# Access Compliance Report

## Public Rights-of-Way

Intersection ID: 42769	Main Street: ERWIN_RIDGE_AV	Cross Street: JEANETTE_CR	Location: SW
ADA ID: 8C3498852334	Ramp Type: BlendTrans1	Initial Pass/Fail: Fail	Overall Compliance: No
Severity Score: 21.25			
Codes/Mitigation Info/Possible Solution		Field Measurements/Component Compliance

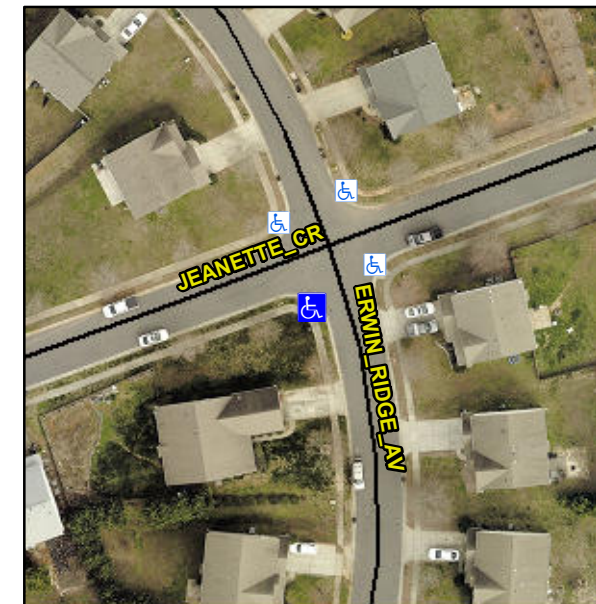
**Not Found, R304.5.1, R304.5.3**

Compliance	Description	Data	Compliance	Description	Data
N/A	Ramp Length (in)	43.0	Yes	BlendTrans Slope (%)	3.3
No	Ramp Width (in)	42.0	No	BlendTrans XSlope (%)	6.9
N/A	Flare Type LT	N/A	N/A	Flare Type RT	N/A
N/A	Flare Slope LT (%)	N/A	N/A	Flare Slope RT (%)	N/A
N/A	Flare Traversable LT?	N/A	N/A	Flare Traversable RT?	N/A
N/A	Landing Length (in)	N/A	N/A	DWS Provided?	N/A
N/A	Landing Width (in)	N/A	N/A	DWS Contrast?	N/A
N/A	Landing Slope (%)	N/A	N/A	DWS Length (in)	N/A
N/A	Landing X Slope (%)	N/A	N/A	DWS Full Width?	N/A
N/A	Landing Curb? (Y/N)	N/A	N/A	DWS Offset (in)	N/A
N/A	Shared Landing?	N/A			
N/A	Gutter Ponding?	N/A	N/A	Gutter Slope (%)	N/A
N/A	Gutter Lip Ht (in)	N/A	N/A	Gutter X Slope (%)	N/A
N/A	Painted X Walk1?	No	N/A	Painted X Walk2?	No
	X Walk 1 Direction	To NE		X Walk 2 Direction	To NW
	X Walk 1 Width (in)	N/A		X Walk 2 Width (in)	N/A
	X Walk 1 Slope (%)	0.9		X Walk 2 Slope (%)	4.5
	X Walk 1 X Slope (%)	5.6		X Walk 2 X Slope (%)	1.0

N/A	Ramp inside XWalk1?	N/A	N/A	Ramp inside XWalk2?	N/A
	Road Slope (%)	4.9		Clear Space?	N/A
	Road X Slope (%)	4.8	N/A	Clear Space to XWalk (in)	N/A
N/A	Any Obstructions?	N/A	N/A	Storm Grate/Utility Hazard?	N/A
	Obstruction Type			Storm Grate/Utility Type	
		N/A			N/A
			Yes	Surface Condition? (G/P)	Good
			No	Curb Slope (%)	12.7

**Remove & Replace Curb Ramp With Two New Directional Ramps or Equivalent.**
